Re: Florida Power & Light Company  
Turkey Point Units 3 and 4  
Docket Nos. 50-250 and 50-251  
Turkey Point Units 3 and 4 Subsequent License Renewal Application  
Safety Review Requests for Additional Information (RAI) Set 4 Responses

Turkey Point Units 3 and 4  
Docket Nos. 50-250 and 50-251  
FPL Response to NRC RAI No. 4.3.3-2  
L-2018-174 Attachment 13 Enclosure 1 Page 1 of 8

Figure 5-1. Leakage Flaw Size versus Normal Operating Stress of Accumulator Lines

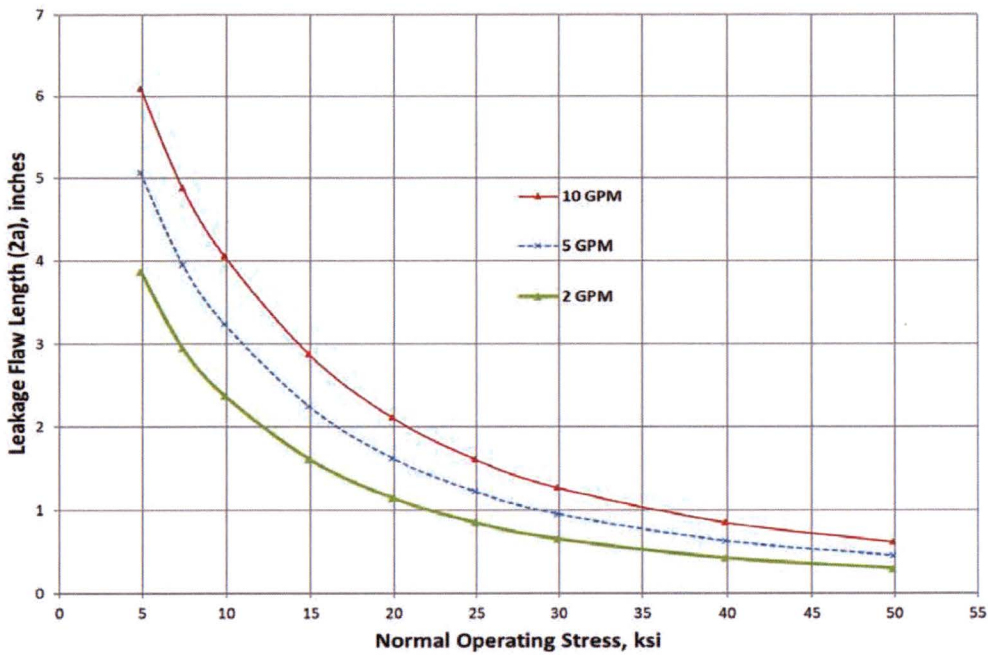
- (d) Provide values of leakage flow size and normal operating stress in Figures 5-1 to 5-6. Identify the limiting leakage flow size for each subject piping in Figures 5-1 to 5-6.

- (d) The values of leakage flow size and normal operating stress have been added to the figures and are provided below. These figures have been used to revise Figures 5-1 to 5-6 in the SIA Report No. 0901350.401, Revision 4.

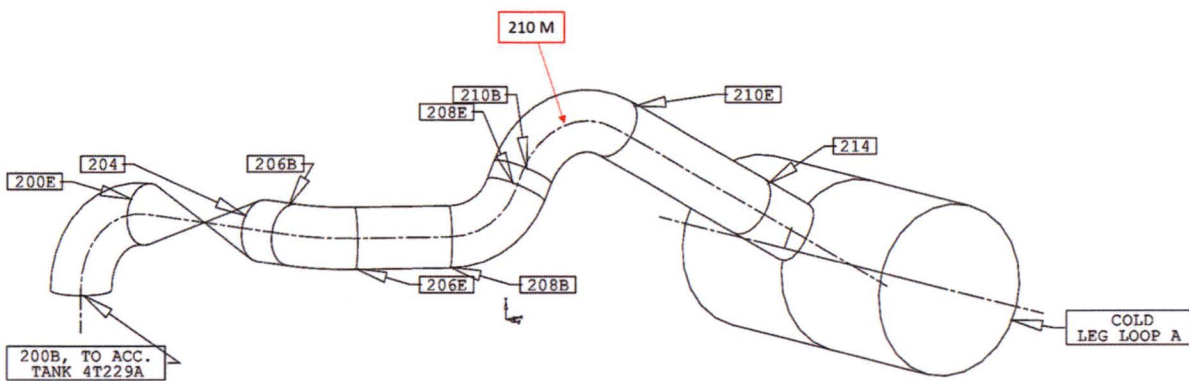
Section 5.4 of SIA Report No. 0901350.401, Revision 3, states that "...From the BACs [bounding analysis curves] and load points plotted in Figure 5-7 to Figure 5-12 all the stress points for both Units 3 and 4 are below 10 gpm BACs except for stress point 210M in the Unit 4 Accumulator Line as shown in Figure 5-7. Since the stress point 210M is in the middle of an elbow, removing the conservatism in using the weld material Z factor for pipe/elbow materials, the BAC is plotted using a Z factor of 1.0 as shown in Figure 5-13. Using a Z factor of 1.0, stress point 210M is under the 10 GPM BAC..."

- (a) It is not clear what conservatism was included in the original analysis. For example, what is the original Z factor used prior to use 1.0 for the Z factor? Page 5-3 discusses the use of Z factor for welds based on the shield metal arc welding process.
- (b) It is not clear why the stress point 210M is located in the middle of an elbow. Figure 4-2 of SIA Report No. 0901350.401, Revision 3, identified only the points associated with the welds at the both ends of the elbow in Loop A of the accumulator line, not in the middle of the elbow.

- (a) Provide the original Z factor used for the 210M stress point in the Unit 4 accumulator pipe in the limit load analysis. Discuss the calculated leak rate using the original Z factor. Discuss the conservatism in the original analysis in terms of the Z factor.
- (b) Clarify the exact location of the stress point 210M as modeled in the pipe stress analysis.

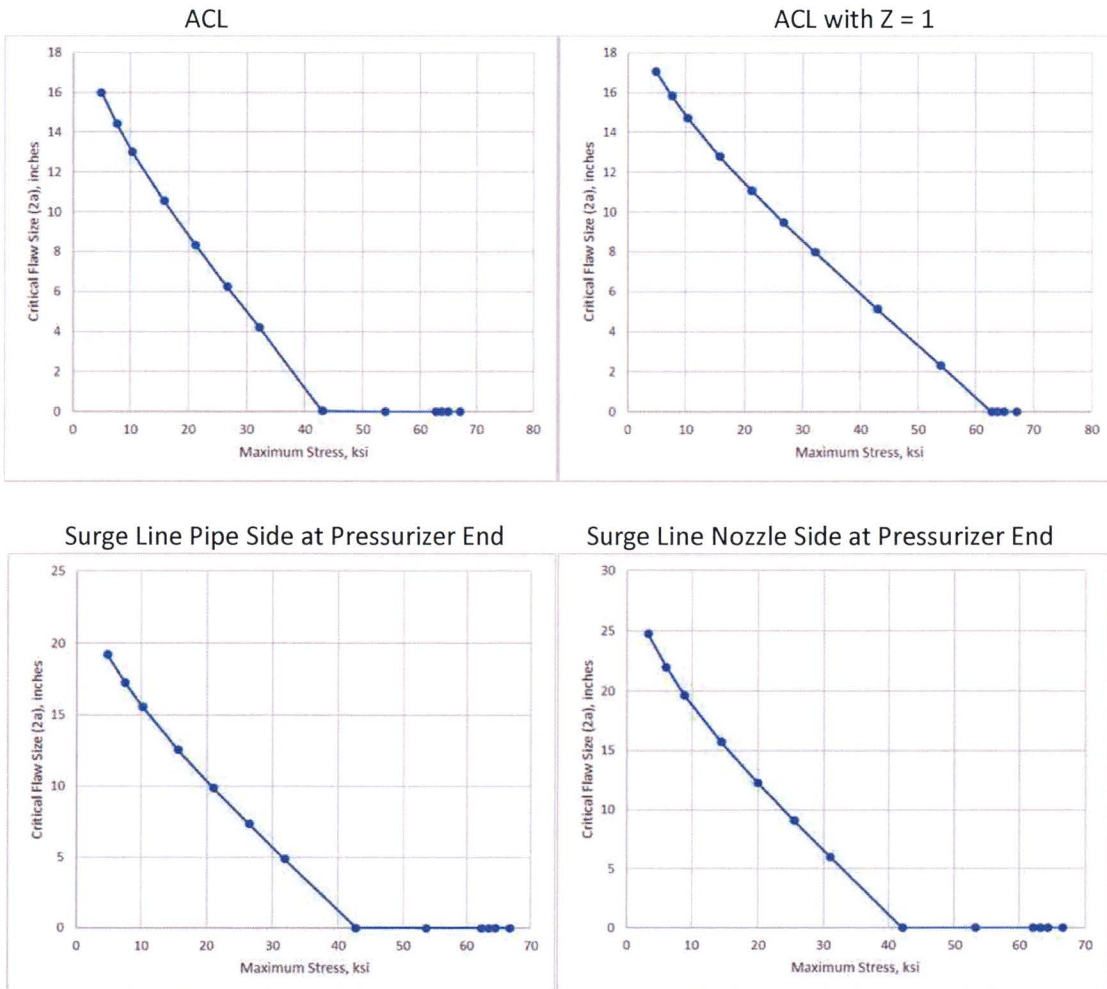
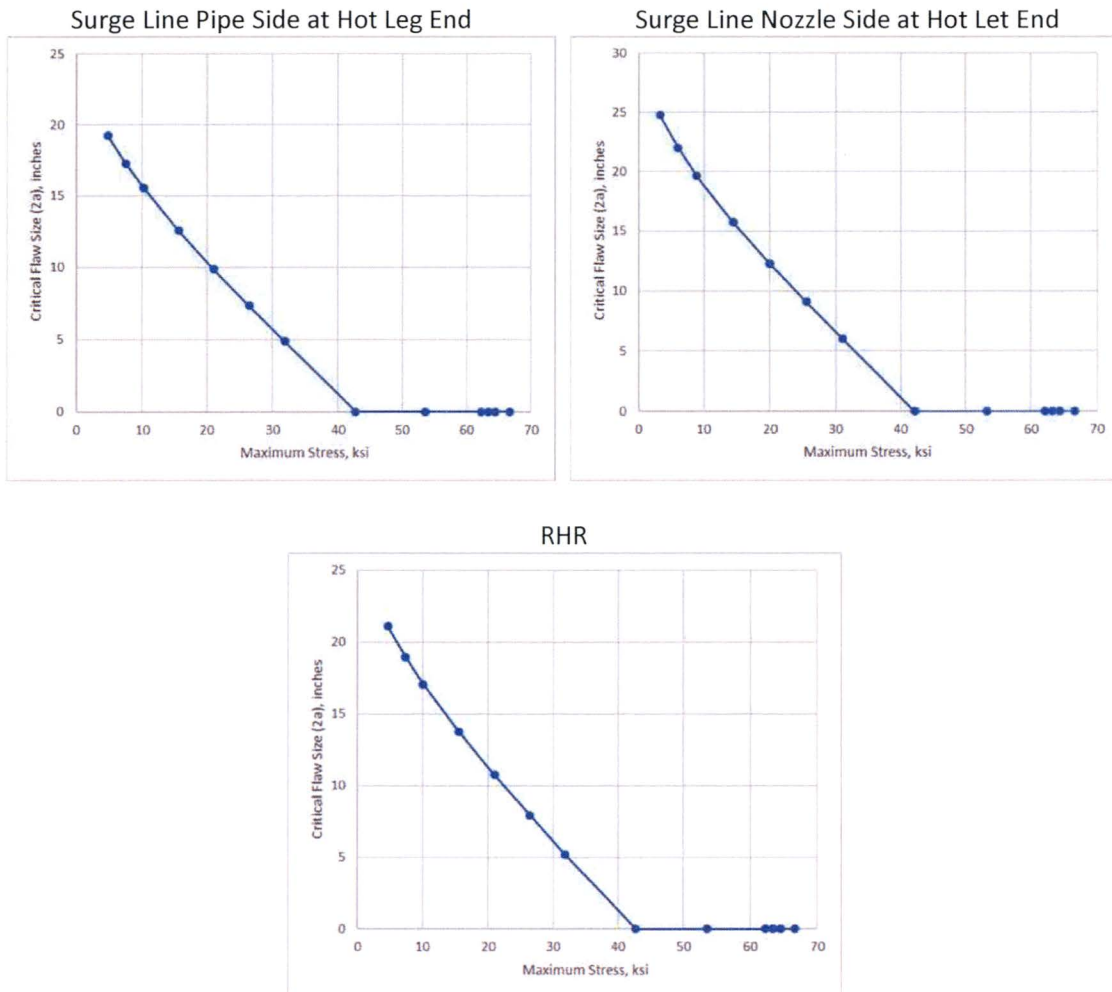
Provide curves of critical crack sizes for each subject piping.

Curves of critical crack size versus maximum stress are provided below. They were inadvertently left out of the report. They have been incorporated in the revised SIA Report No. 0901350.401, Revision 4.
